CZECH SPORT AIRCRAFT	<h1>SERVICE BULLETIN</h1> <div style="border: 1px solid red; padding: 5px; display: inline-block; margin: 10px 0;"> <h2 style="margin: 0;">MANDATORY</h2> </div>	Czech Sport Aircraft a.s. Na Záhonech 212 686 04 Kunovice Czech Republic info@czechsportaircraft.com
		No.: SB-SC-076
		Date: 2019-09-27
		Page: 1 of 4
		Rev.: - Date: -

MODEL AFFECTED:	SportCruiser / PiperSport (excluding those operating under EASA rules)
SUBJECT:	Inspection and eventual replacement of carburetor circlip for Rotax engine type 912 (Series)
AIRCRAFT AFFECTED:	<p>All SportCruiser / PiperSport aircraft with Rotax engine types 912 Series if at least one of the A), B) or C) below mentioned criteria applies.</p> <p>Criterion A) Engine serial number:</p> <p style="padding-left: 40px;">From S/N 6784306 up to S/N 6787000 inclusive From S/N 9565001 up to S/N 9573266 inclusive From S/N 9573268 up to S/N 9573271 inclusive From S/N 4924905 up to S/N 4925000 inclusive From S/N 9139001 up to S/N 9139252 inclusive From S/N 9563601 up to S/N 9565000 inclusive</p> <p>Criterion B) Carburetors:</p> <p style="padding-left: 40px;">1/3 part. no. 892530: From S/N 145021 up to S/N 191489 inclusive From S/N 191

Fig. 0: Rotax 912 carburetor

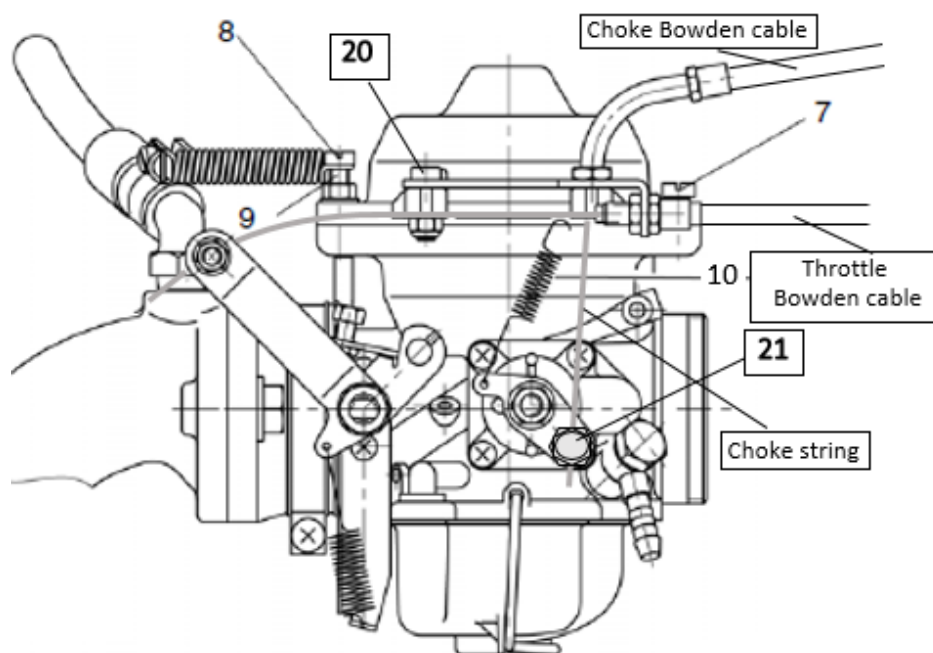
1. Check the aircraft / engine logbook and maintenance documentation, if this Service Bulletin has already been accomplished.
2. Check the criteria given in Section "AIRCRAFT AFFECTED", if the aircraft is affected by this Service Bulletin.
3. Move the aircraft to a suitable place to perform the work.
4. Remove the engine upper cowling (see the SC-AMM-1-0-00, the latest revision).
5. Disconnect the battery terminals (see the SC-AMM-1-0-00, the latest revision).
6. Remove the oval head screw (20), see Fig. 0.
7. Loose the choke screw (21) and release the choke control string, see Fig. 0.
8. Cut the tapes fixing throttle and choke Bowden cables.

9. Follow instructions in the ROTAX Service Bulletin no. SB-912-073.
10. Screw and fix the oval head screw (20), see Fig. 0.
11. Install the choke control string and fix the choke screw (21), see Fig. 0.
12. Use fixing tapes and attach and fix the throttle and choke Bowden cables.
13. Adjust the choke control string, see the SC-AMM-1-0-00, Point 10.4, the latest revision.
14. Connect the aircraft battery terminals.
15. Install the engine upper cowling (see the SC-AMM-1-0-00, the latest revision).
16. Restore the aircraft to the airworthy condition.
17. Perform engine run test (see the SC-AMM-1-0-00, the latest revision).
18. Complete the aircraft records (log book) to reflect compliance with this Service Bulletin.
19. Thereby, the performance of this Service Bulletin is completed.
